# ***Japan Presentation***    *EVS-GTR IWG\_ September, 2017*

## *Considerations for transposing EVS-GTR Phase 1*

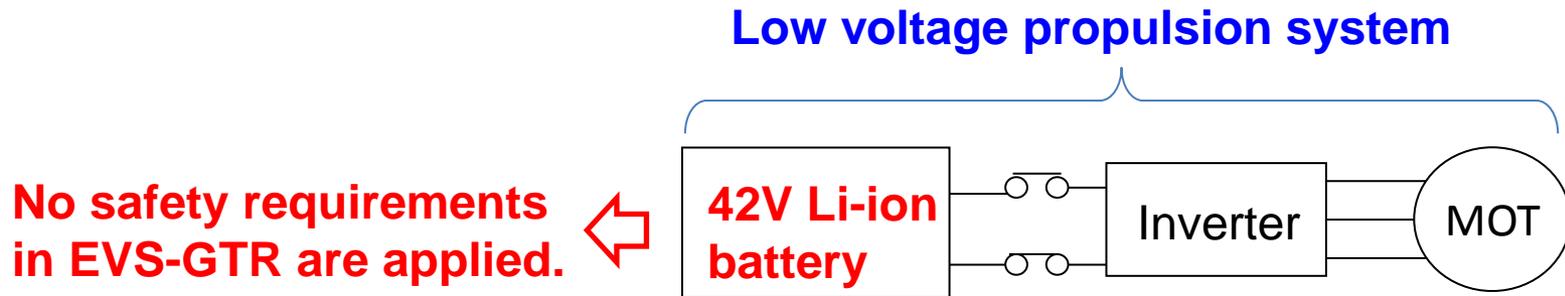
It is not clear whether the domestic socket outlet in passenger compartment is **excluded or not**.

**Isolated connection**

The socket outlet **cannot meet** the **IPXXD** requirement in EVS-GTR.

If the requirements are applied to the socket outlet, the vehicle is **non-compliant** to EVS-GTR.

UNR100 mentions that “**galvanically connected** to the electric power train” and the socket outlet isolated from vehicle propulsion system is **out of the scope**.

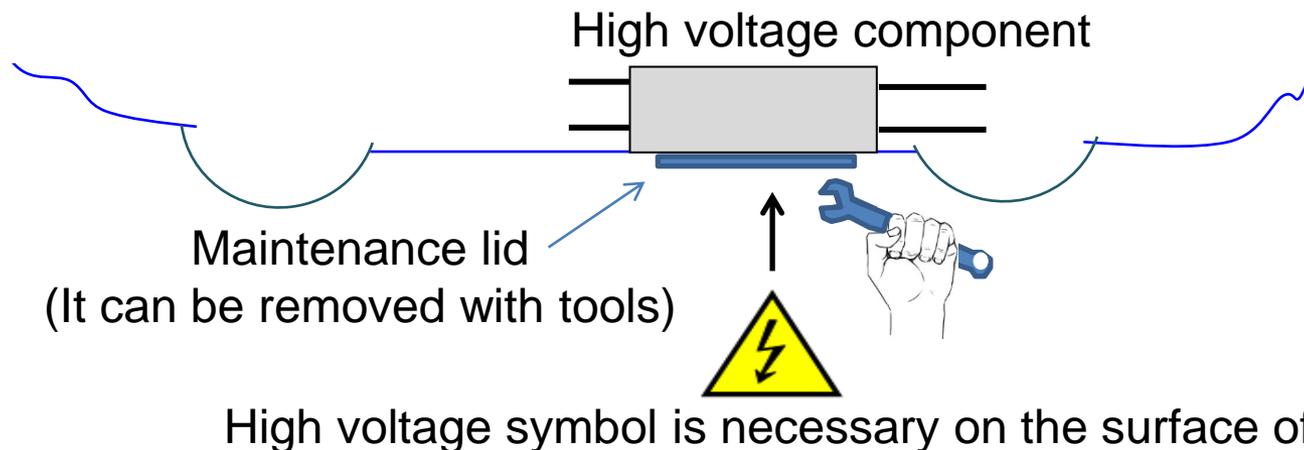
If a maintenance lid exists underneath the vehicle floor and it can be accessed and removed with using tools, the high voltage symbol is necessary on the lid.

### Issues

**If a yellow color symbol is required, the symbol is printed on a label.**

**It is difficult to ensure durability of the label over the vehicle service life.**
